# MORGAN OFFSHORE WIND PROJECT: GENERATION ASSETS

Technical engagement plan appendices part 4 (Appendix D)

Document Number: MRCNS-J3303-RPS-10031

## Appendix D: Offshore Ornithology EWG

Figure 1: Aerial digital survey areas for Mona and Morgan Offshore Wind Projects

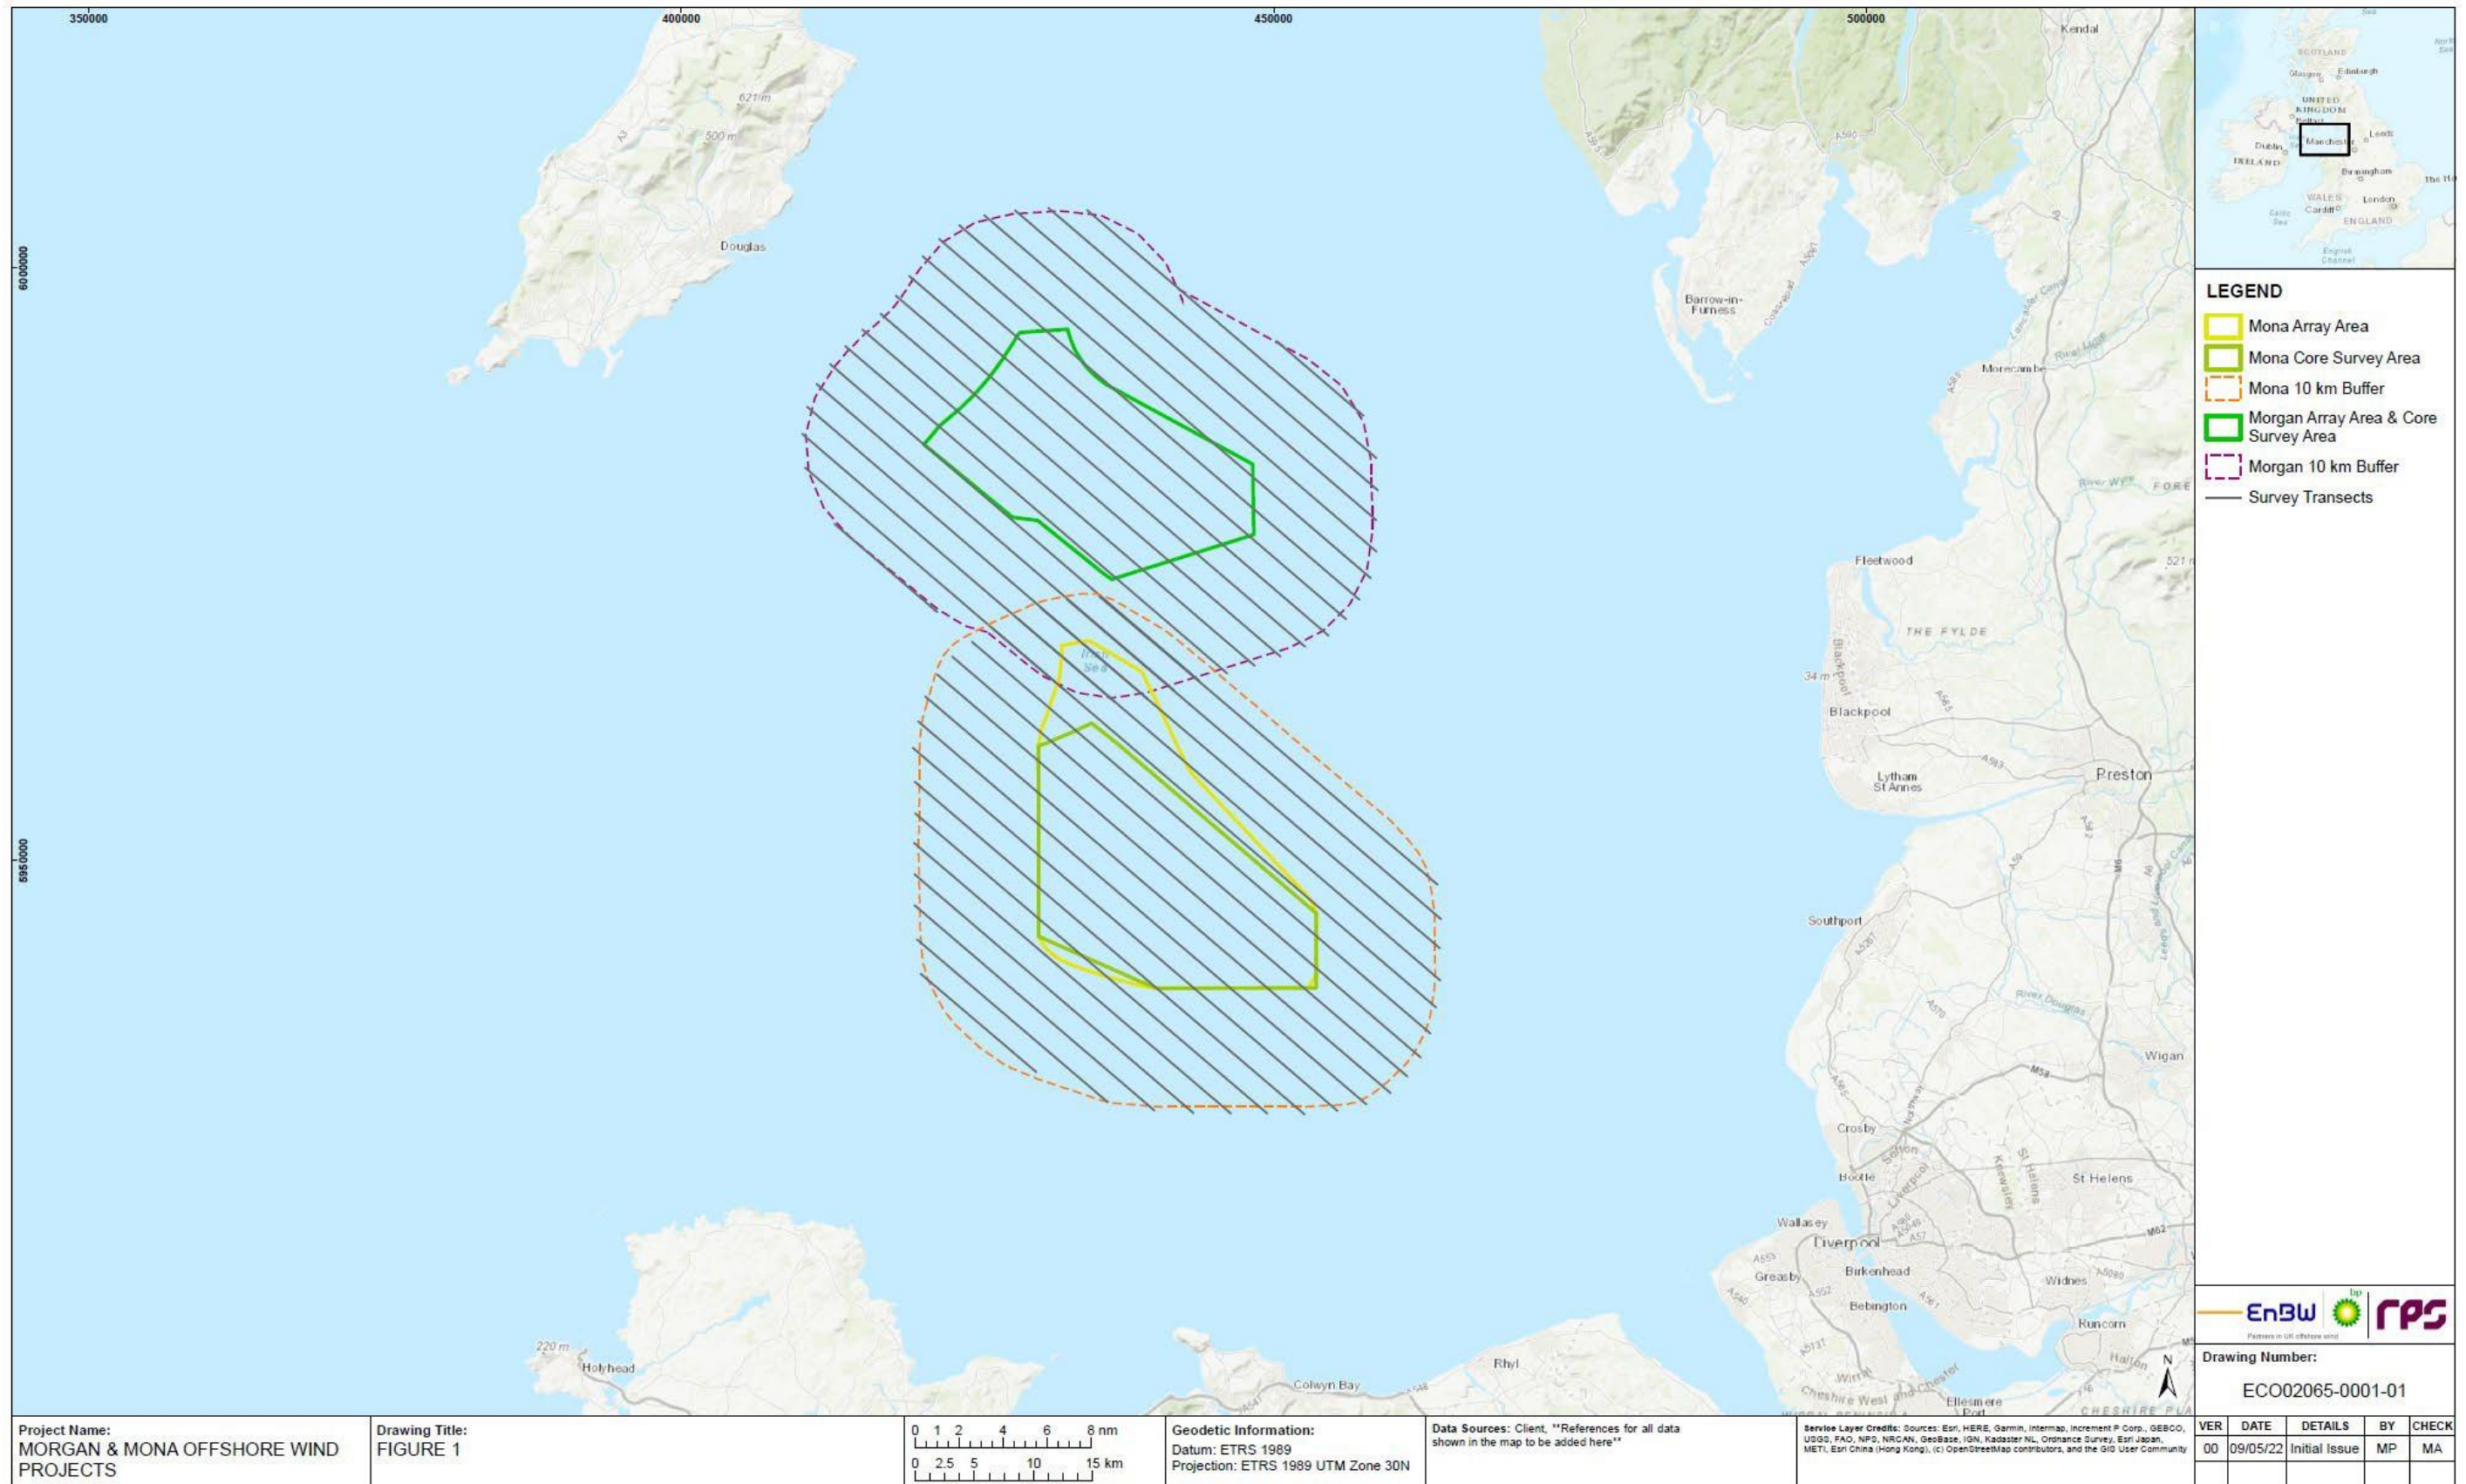
Please note that there is revised guidance available for Red-Throated Diver displacement in the Joint SNCB Interim Advice On The Treatment Of Displacement For Red-Throated Diver (2022). *Figure 1: Aerial digital survey areas for Mona and Morgan Offshore Wind Projects* appears to show a 10 km buffer around the whole site, as such, the reasons for not including survey data from a full 10 km buffer around the site(s) is unclear.

NRW (A) advise that further information on how the survey design has been arrived at is needed, including more detail on the justification for the analysis of images across 12% of the offshore ornithology study area. To determine whether survey coverage and design provide an adequate baseline characterisation, NRW (A) advise that evidence from a power analysis is used. The level of coverage required to be sufficient for baseline characterisation will depend on the nature of the area being surveyed and the abundance and distribution of receptors across the area. A power analysis should be undertaken to inform survey design and ensure that such designs maximise the probability of detecting changes in abundance and distribution through future comparison with data that may be collected post-consent. Webb *et al.*, (2014) provide some examples of power analyses applied to sampling of focal bird species within a marine Special Protection Area (SPA).
